Byron Station, Units 1 and 2
Facility Operating License Nos. NPF-37 and NPF-66
NRC Docket Nos. STN 50-454 and STN 50-455

Subject: Third Six-Month Status Report in Response to March 12, 2012 Commission Order Modifying Licenses with Regard to Requirements for Mitigation Strategies for Beyond-Design-Basis External Events (Order Number EA-12-049)

**Third Six-Month Status Report for the Implementation of Order EA-12-049, Order
Modifying Licenses with Regard to Requirements for Mitigation Strategies for Beyond-
Design-Basis External Events**

Update Mechanical One Line Diagrams

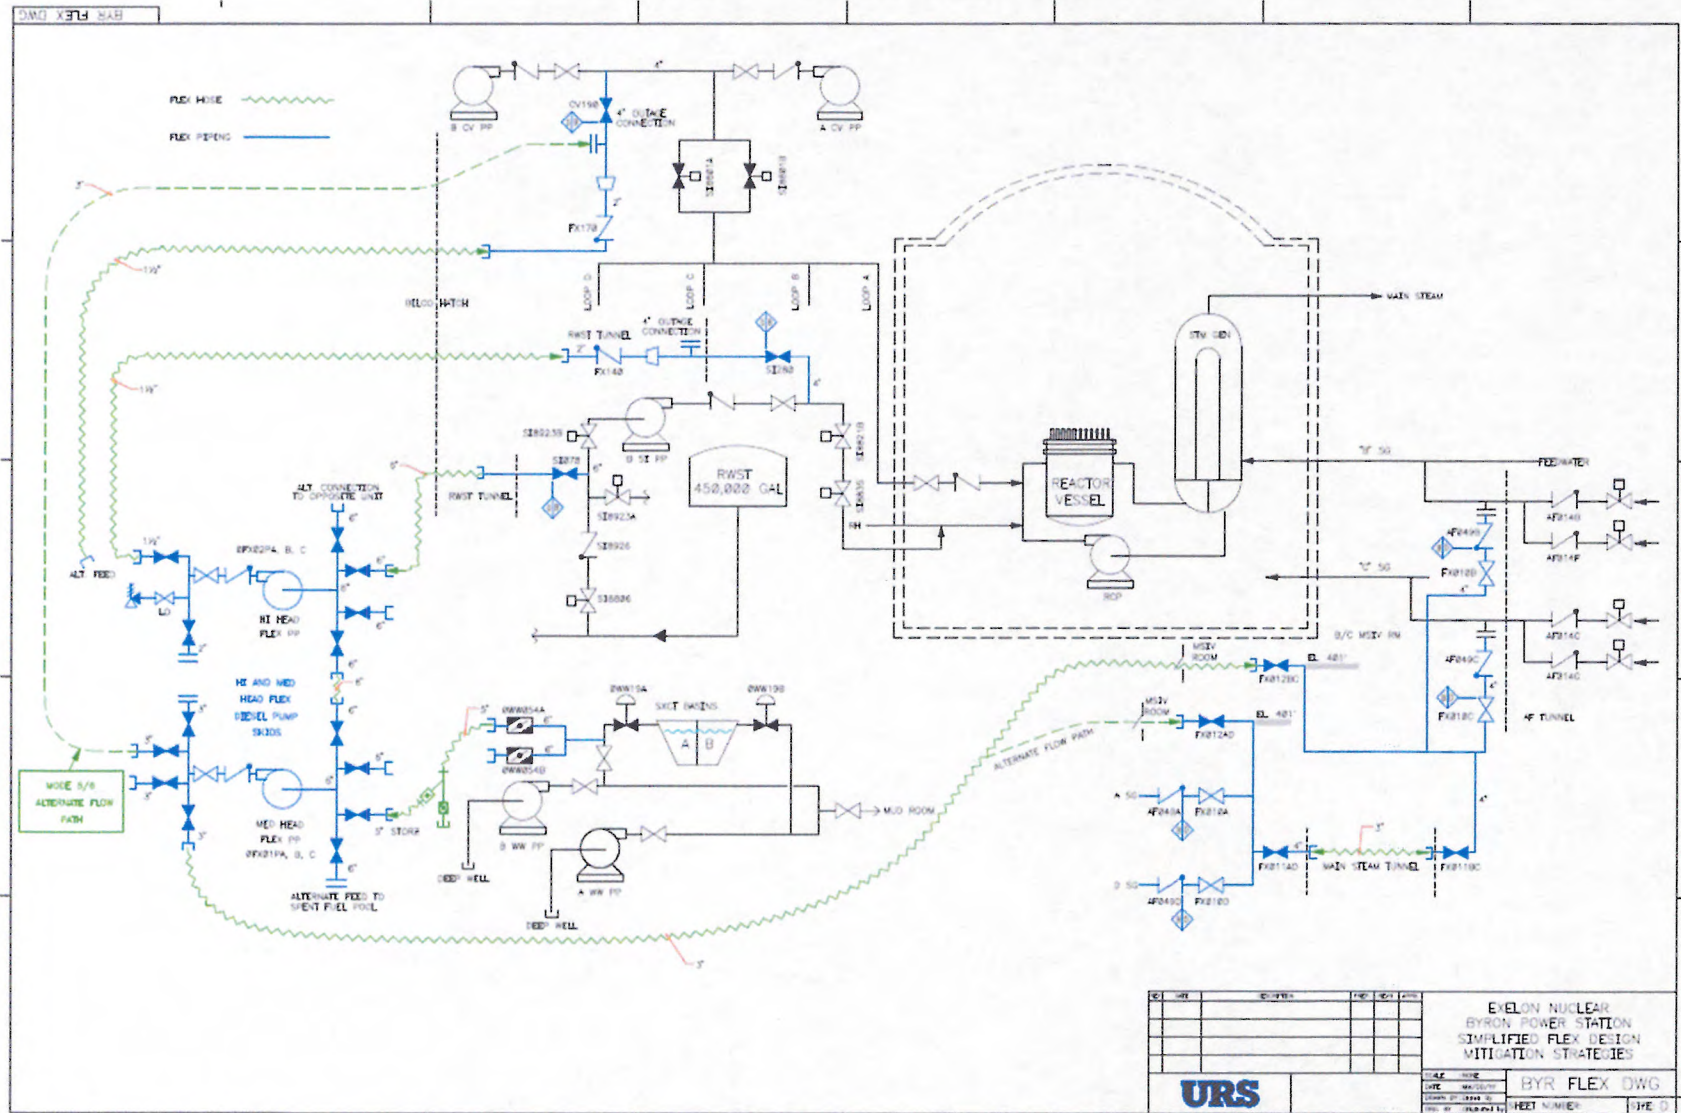
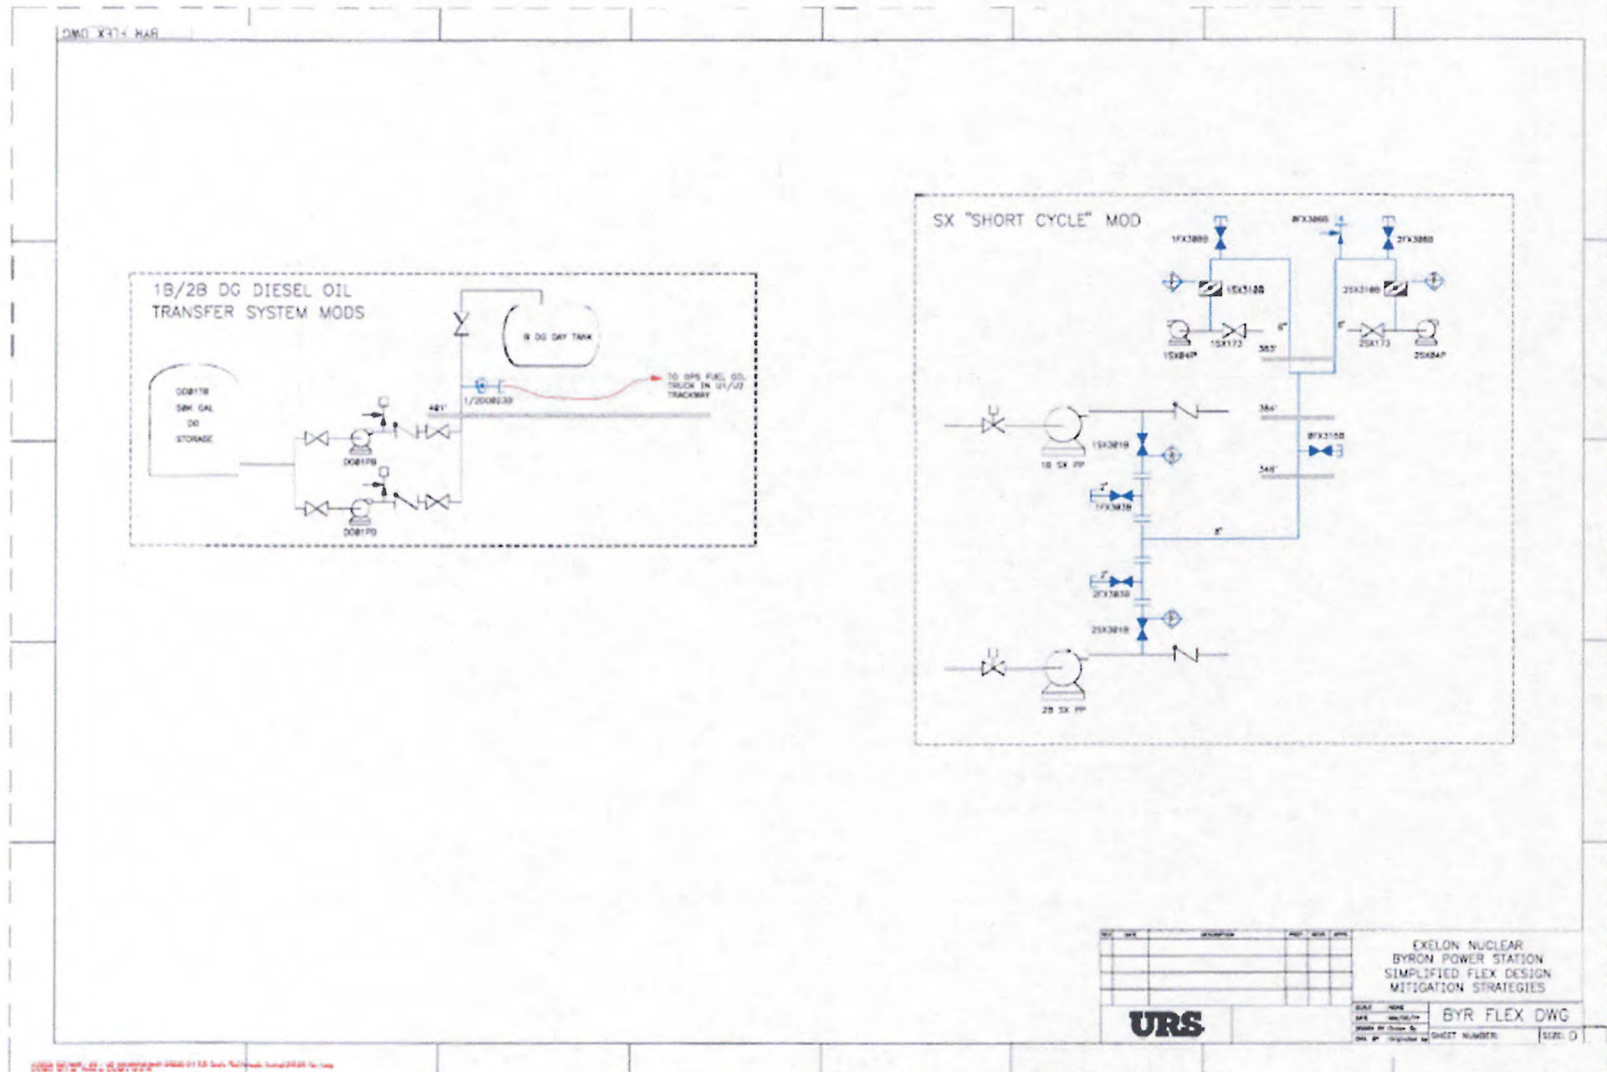
Reason for Change: Updated sketches as a result of refining the site strategy.

Change: Updated sketches are in Attachment 3 of this document.

Electrical Primary Strategy

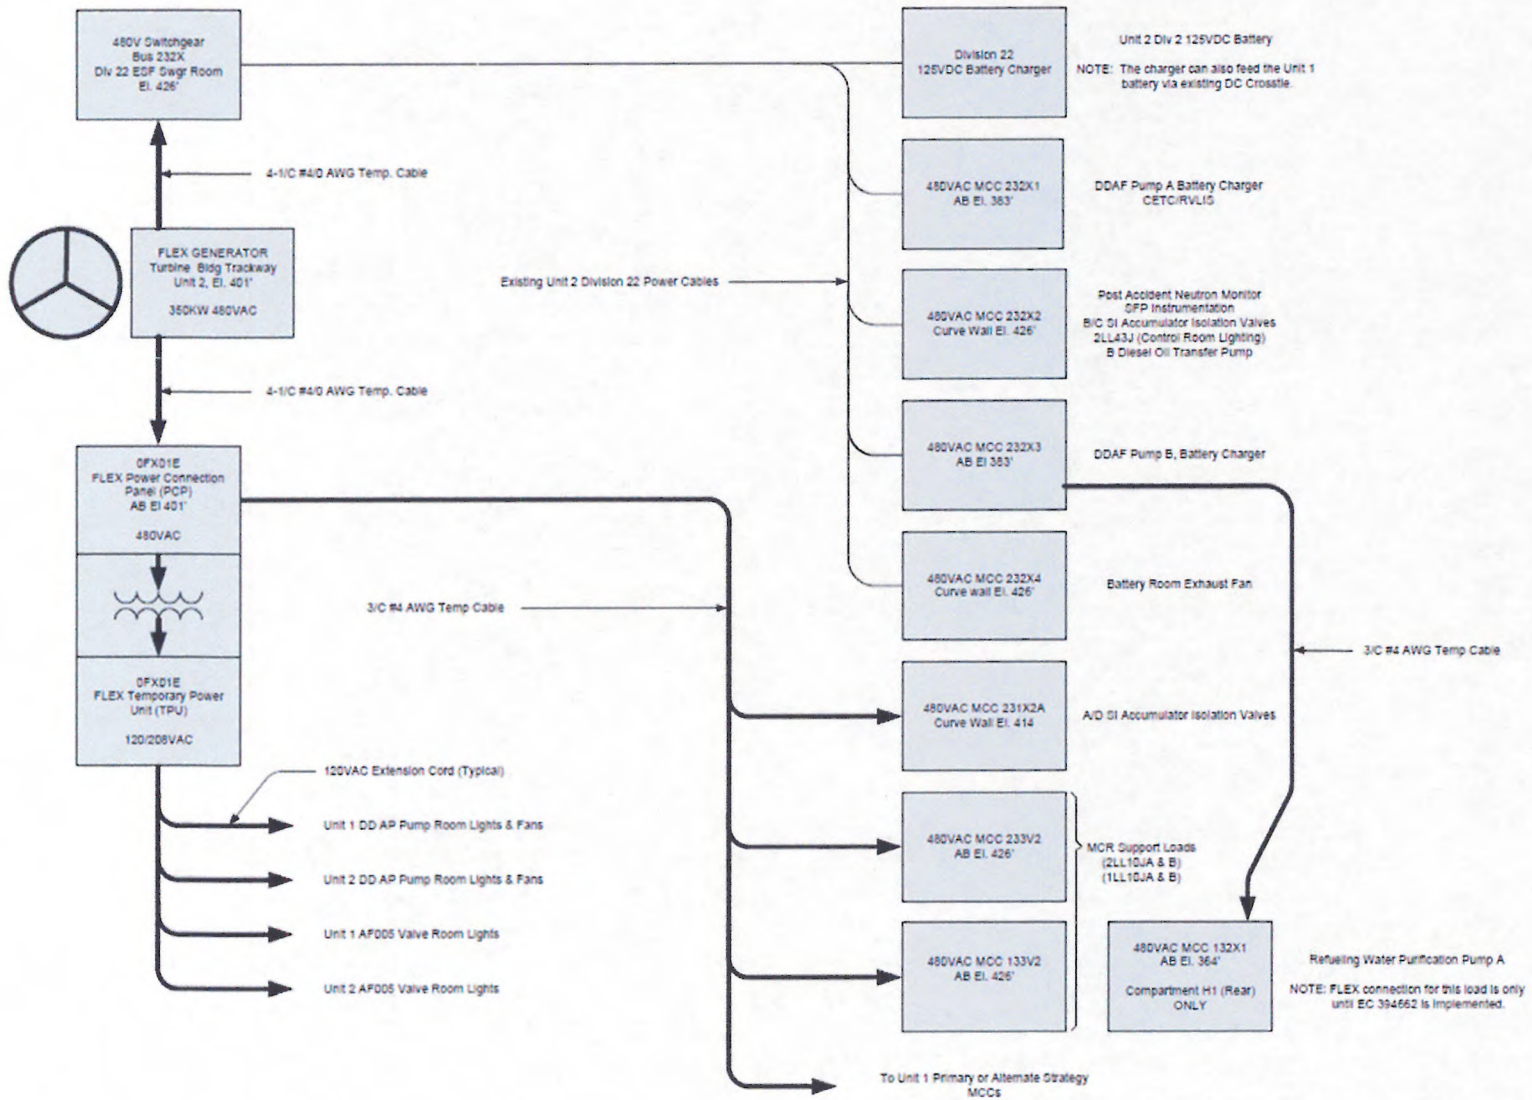
Change: The following modifications will be installed to support the FLEX generator for repowering Division II of station DC batteries:

The primary FLEX connection uses a Bus Connection Device, BCD, installed in a cubicle of BUS 132X and 232X.

The BCD will have the line side connections extending through the breaker frame to standard TPC FLEX electrical connections. Temporary cables will be routed from the TPC connections to the associated units FLEX generator at the 401' turbine building trackway entrance. The BCD and cables will be stored within the associated 4Kv switchgear room to improve operator response time. Once the BUS is energized, appropriate breakers will be closed to provide power to the safety related batteries.
